Model: Adonis-C2 DF70		Date: 22-Jun-01	No.: MB351001
Modified Article: Top Cover and Rear Cover		Prepared by: E. Fukuyama	
From: Technical Services Dept., GTS Division			
Reason for Modification:	☒ Parts catalog correction ☐ To facilitate assembly ☐ Part standardization	☐ Vendor change ☐ To improve reliability ☐ Other	☐ To meet standards ()

Model: Adonis-C2 ARDF (DF70)		Date: 12-Nov-01	No.: MB351002
Modified Article: Rear Hook		Prepared by: E. Fukuyama	
From: Technical Services Dept., GTS Division			
Reason for Modification:	☐ Parts catalog correction ☐ To facilitate assembly ☐ Part standardization	☐ Vendor change ☐ To improve reliability ☒ Other	☐ To meet standards ()

Model: Adonis-C2 ARDF (DF70)		Date: 16-Sep-04	No.: MB351008
Modified Article: Platen Sheet		Prepared by: K. Takagi	
From: 1st Tech. Support Sec. Service Support Dept.			
Reason for Modification:	☐ Parts catalog correction ☐ To facilitate assembly ☒ Part standardization	☐ Vendor change ☐ To improve reliability ☐ Other	☐ To meet standards ()

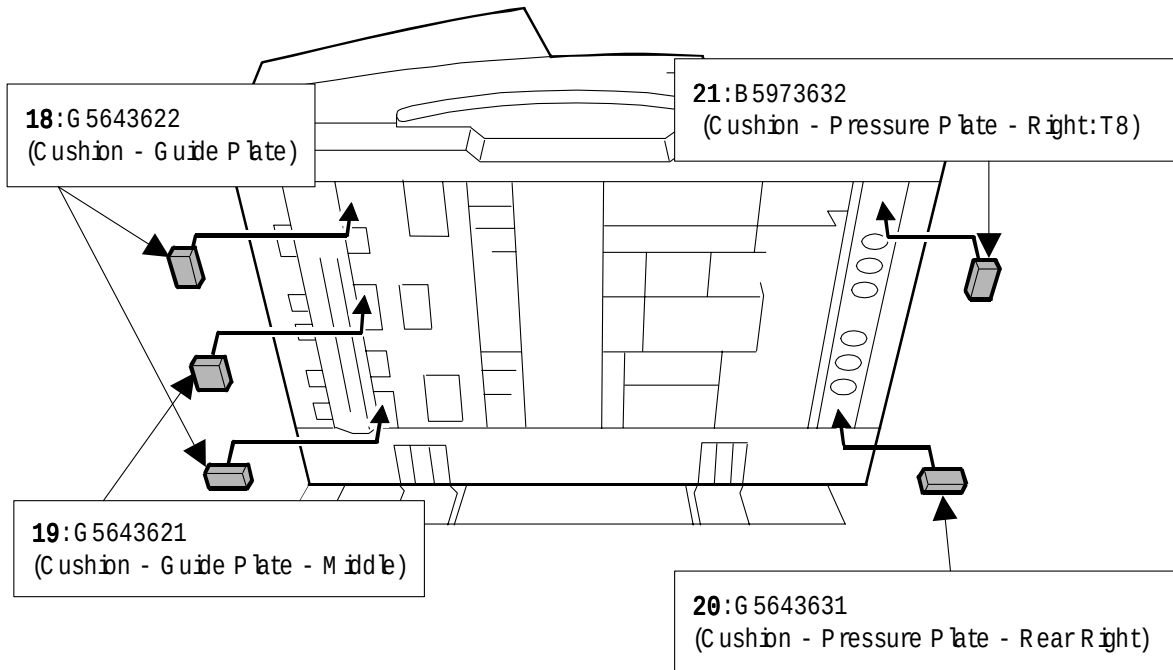
Old part number	New part number	Description	Q'ty	Int	Page	Index	Note
B3514311		Platen Sheet					
	B5974311	Pressure Plate Assy	1	X/O	21	10	
B3514333	-	Cushion - Pressure Plate	2-0		21	15	
B3514322	B3514322	Tape - Platen Sheet	4-1		21	9	
	B5974326	Cushion Tape - Left	2		21	16	
	B5974333	Cushion Tape - Middle	2		21	17	
	G5643622	Cushion - Guide Plate	2		21	18	
	G5643621	Cushion - Guide Plate - Middle	1		21	19	
	G5643631	Cushion - Pressure Plate - Rear Right	1		21	20	
	B5973632	Cushion - Pressure Plate - Right: T8	1		21	21

Reason: Parts standardization with the Model - JC1 ARDF (DF77).

Installing the Velcro Patches (“Cushion” and “Cushion Tape”)

1. Remove the Platen Sheet.
2. Remove the 5 old Velcro patches from the underside of the ADF.
3. Attach the new Velcro patches to the underside of the ADF (#18-21 below).

4. Attach the new Velcro patches to the underside of the Pressure Plate (#9, 10, 16, 17 below):
